BOWRAL BRICKS

NEW BERRIMA BRICKWORKS FACILITY (SSD 10422)

RESPONSE TO EPA ADVICE ON SUBMISSIONS REPORT

Report Number	Date Issued	Version	Prepared	Checked	Released
JAN21002.1	25 February 2021	V1 – Response to EPA Advice	A Aitharaju	A Aitharaju, B Bhensdadia	A Aitharaju

Figure 1: Extent of Exceedance of the 24-hour average HF Concentrations on Impact Area 2 (Represented by the Solid Orange Coloured Area)

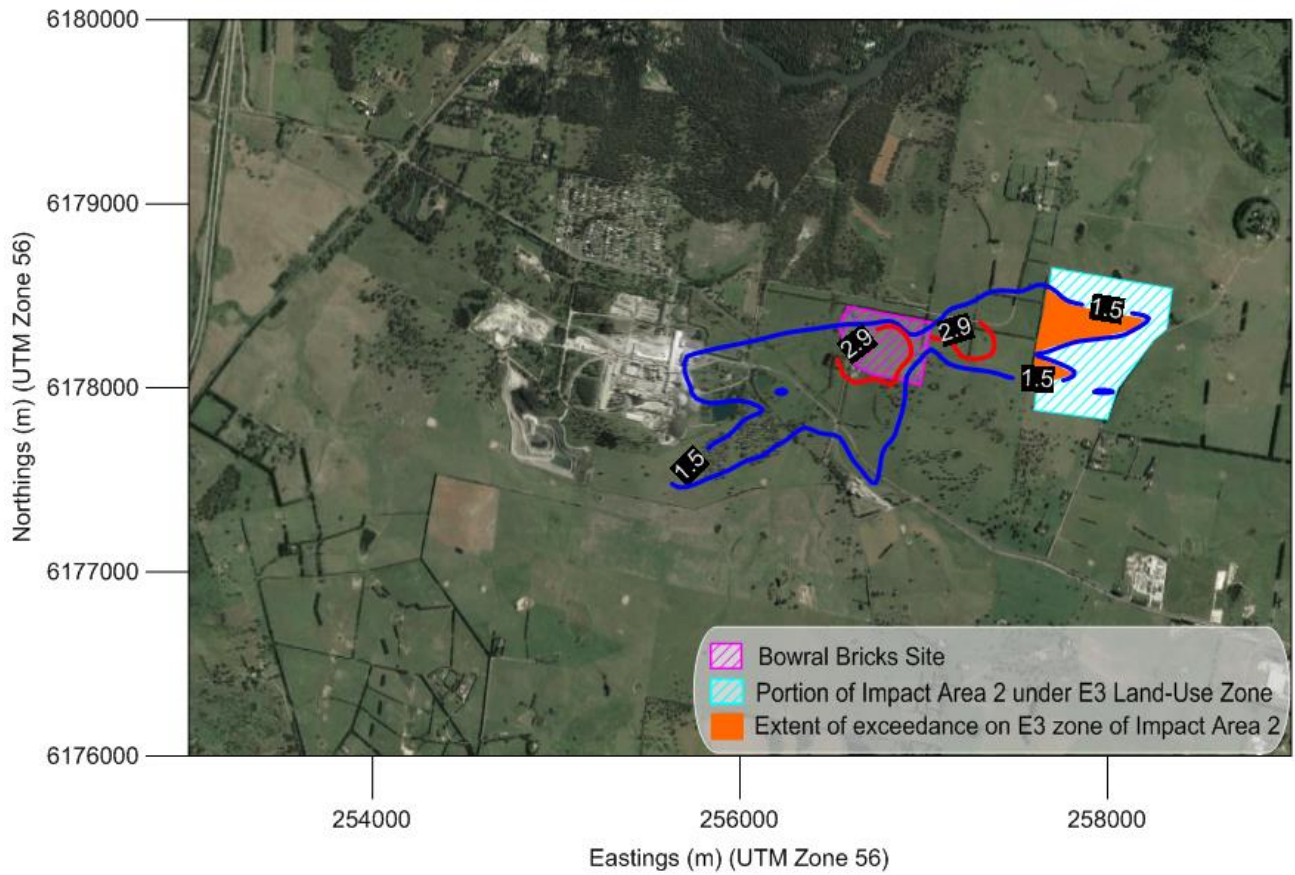
The EPA recommends the proponent be required to provide supporting evidence of the information considered in Airlabs survey of the potential for sensitive lands surrounding the proposed project site.

- EPA reviewed the incremental and cumulative HF concentration isopleths and noted that the worst impacts are predicted for the 24-hour averaging periods. EPA in their comments mention that when the sensitive land use assessment criteria (1.5 $\mu\text{g}/\text{m}^3$) is applied for the interpretation

of the 24-hour averaging period concentrations, results of the dispersion modelling show predicted concentrations above the impact assessment criteria in the land zoned E3 to the north-west of the proposed facility and further note that there is potential that future specialised land use in this area may be affected including vegetation sensitive to fluoride – such as grape vines and stone fruits.

- Impact Area 2 has a combination of two (2) land-use categories - E3 and IN1. E3 component of Impact Area 2 is shown as light-blue coloured hatched area in **Figure 1**. Across the E3 component of Impact Area 2, predicted 24-hour average concentrations (shown in **Figure 1** as solid orange colour blocks) exceed the sensitive land use assessment criteria for an area which is limited to a maximum area of approximately 10 ha in size. Across the remaining area E3 component of Impact Area 2, the predicted concentrations comply with the sensitive land use assessment criteria.

- Based on the above observations, it can be summarised that the 24-hour average fluoride ground level concentrations exceed the sensitive land use assessment criteria only on two (2) lots across land use that is categorised as E3 – Environmental Management by the Wingecarribee Local Environmental Plan 2010, of which one (1) lot belongs to Austral Bricks – where the proposed quarry would be developed and on the other site, concentrations above the sensitive land use assessment criteria are limited to a maximum area of approximately 10 ha in size on the land that is categorised as E3.
